Application of SOUTHERN CALIFORNIA  
EDISON COMPANY, ET AL. for a Class 103  
License to Acquire, Possess, and Use  
a Utilization Facility as Part of  
Unit 2 of the San Onofre Nuclear  
Generating Station

Amendment Application  
No. 126

DESCRIPTION AND SAFETY ANALYSIS  
OF PROPOSED CHANGE NPF-10/15-406

This is a request to revise Technical Specification (TS) 3/4.9.7, "Fuel Handling Machine - Spent Fuel Storage Pool Building." This change will permit long-term use of the spent fuel cask pool cover.

FIGURE 1

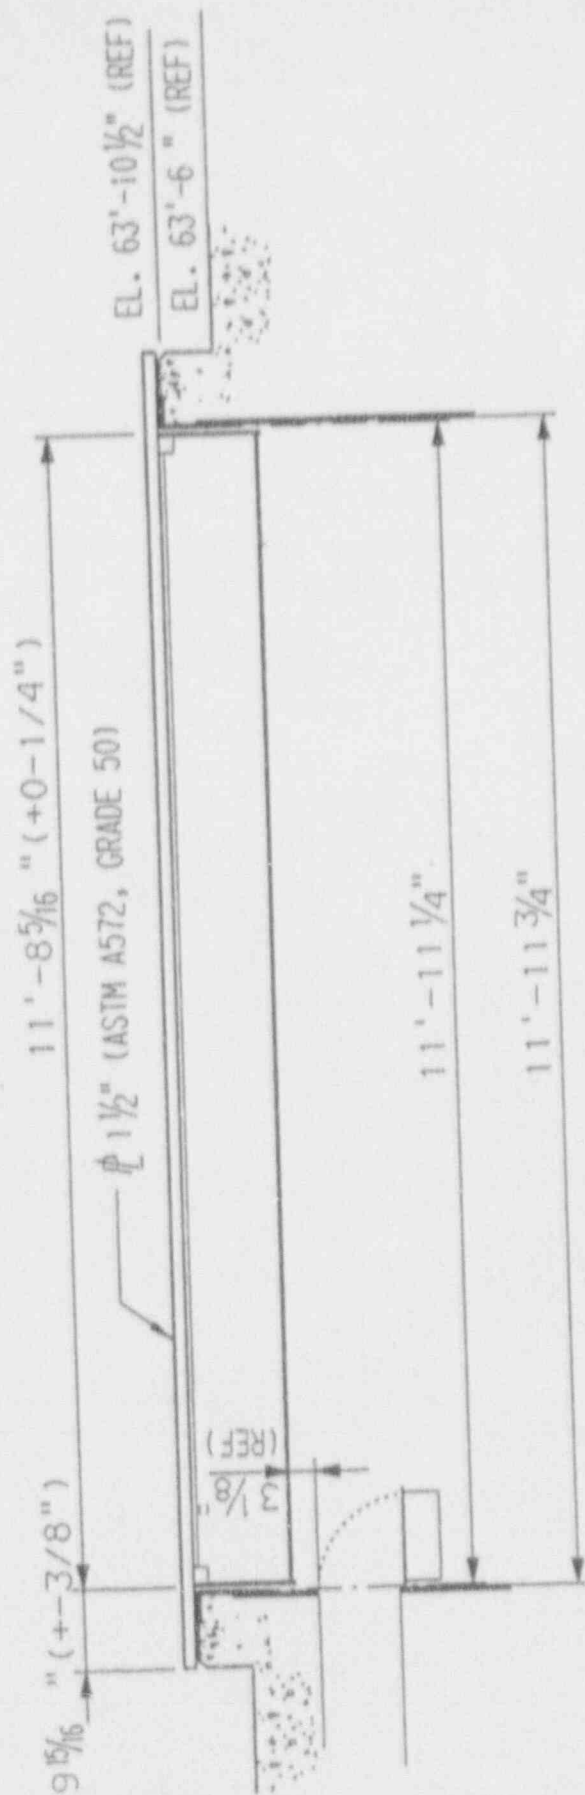
The cask pool cover (see Figures 1 and 2), the same cover previously approved and used during reracking, consists of four segments which will be bolted together with installation beams (strongbacks) to create one complete assembly prior to its placement over the cask pool. The cover assembly will be lifted by the Cask Handling Crane (CHC) then lowered over the cask pool until it rests on the cask pool curbs. Once in place the strongbacks would normally be removed, and the confining nature of the cask pool walls will hold the cover in place.
